DEVELOPMENT NO.:	23035583
DEVELOPIVIENT NO	25055505
APPLICANT:	Lianne Sordillo
ADDRESS:	23 HIGHLANDS COURT WOODFORDE SA 5072
NATURE OF DEVELOPMENT:	Variation to DA 22022718 - to increase wall height of dwelling
ZONING INFORMATION:	Zones: Housing Diversity Neighbourhood Overlays: Affordable Housing Hazards (Bushfire - Urban Interface) Hazards (Flooding - Evidence Required) Prescribed Wells Area Regulated and Significant Tree Stormwater Management Traffic Generating Development Urban Tree Canopy Water Resources Technical Numeric Variations (TNVs): Maximum Building Height (Metres) (Maximum building height is 9m) Maximum Building Height (Levels) (Maximum building height is 2 levels)
LODGEMENT DATE:	13 Dec 2023
RELEVANT AUTHORITY:	Assessment Panel at Adelaide Hills Council
PLANNING & DESIGN CODE VERSION:	P&D Code (in effect) - Version 2023.18 7/12/2023
CATEGORY OF DEVELOPMENT:	Code Assessed - Performance Assessed

DETAILED DESCRIPTION OF PROPOSAL:

The proposed variation is seeking to increase the wall height of the dwelling by 900mm due to an increase in ceiling height on the upper and lower ground levels. It is noted that due to an adjustment to the lower ground floor level which has

SHADOW DIAGRAM JUNE 21 9AM 1:200

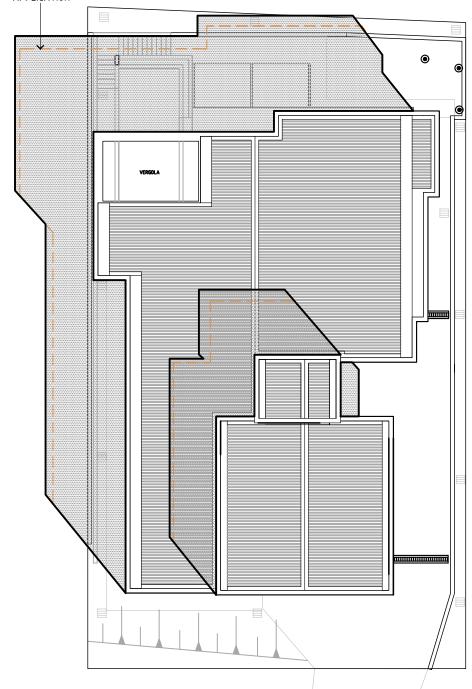
The applicant has provided shadow diagrams to demonstrate that the shortfall in these sections of the side setbacks will not unreasonably impact access to natural light for immediate neighbours. These are discussed in further detail in later sections of the report. The shortfall is also not considered likely to risk lack of ventilation to neighbours given that the dimension of both setbacks is 2 metres.

The revised shadow diagrams show the increased wall height resulting in a negligible increase to the level of overshadowing to the adjoining property to the south-east. The adjoining dwelling will continue to receive at least three hours of sunlight to north-facing habitable room windows and at least two hours of sunlight to more than half of the ground level private open space during the winter solstice, as sought by DPF 3.1 and DPF 3.2 of the General Development Policies (Interface between Land Uses).

STREETSCAPE ELEVATION 1:200

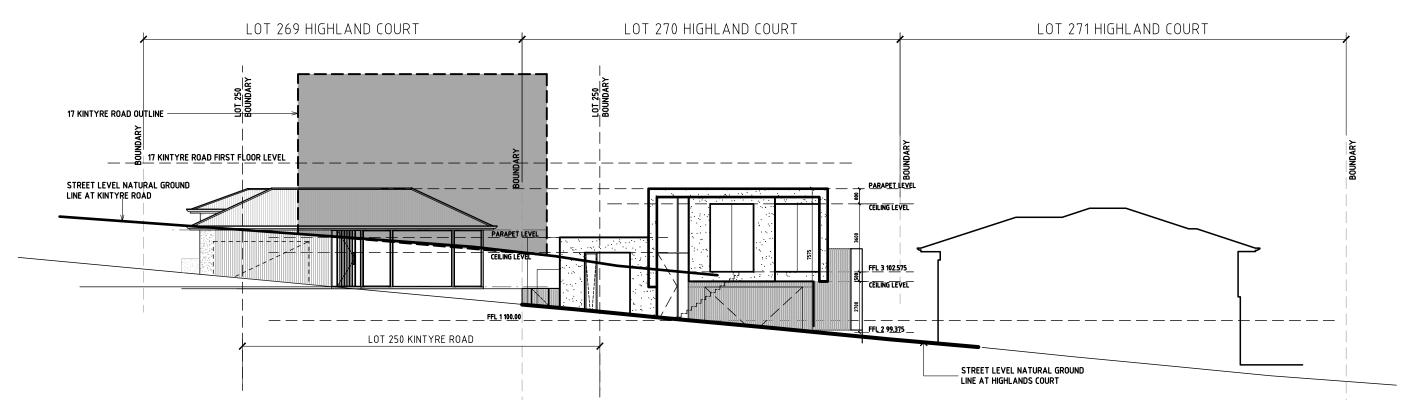
The building as viewed from Highlands Court presents as two storey and through this variation the front façade would increase in height by 900mm to 8 metres. As such, it is considered that when viewed from street level the dwelling would present no differently to a two-storey dwelling built up on fill at a height consistent with Zone DPF 3.1. The dwelling's tallest section is located centrally on the site where the visual bulk is concealed from the street.

We do comply with the maximum building height as such height is taken from the front of the allotment and we are well below the 9000mm maximum, ranging from 6131mm on the eastern side and 7575mm on the western side.

We have reduced the walk in robe parapet height (in this latest set of drawings) to match the main parapet height as can be seen in the attached drawings.

NORTH/WEST ELEVATION 1:100

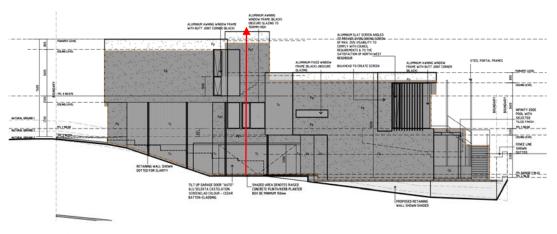
Whereas this dwelling was approved with a maximum height of some 10 metres above the ground level immediately below, a further 0.8 metres is now sought further exacerbating the original departure from clearly expressed planning policy.

The resultant effect is a significant increase is visual bulk beyond that which was originally approved, which in itself substantively departed from clearly expressed planning policy in relation to height at the time.

STREETSCAPE ELEVATION 1:200

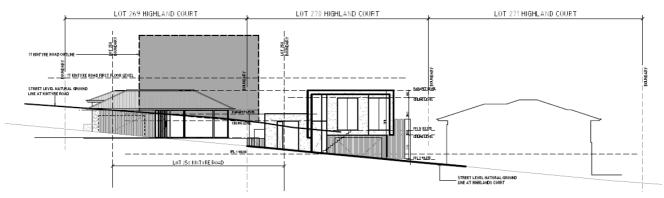
The main reason for this representation is that the representor will lose their view. This is not true, 17 Kintyre Road is on the higher side of the development and based on the documents we were provided we have determined that the floor levels can achieve views to the Adelaide CBD and beyond as the line of sight is above our highest point, further more as the width in our first floor is less than 50% of the allotment width, views can also be achieved between the dwellings.
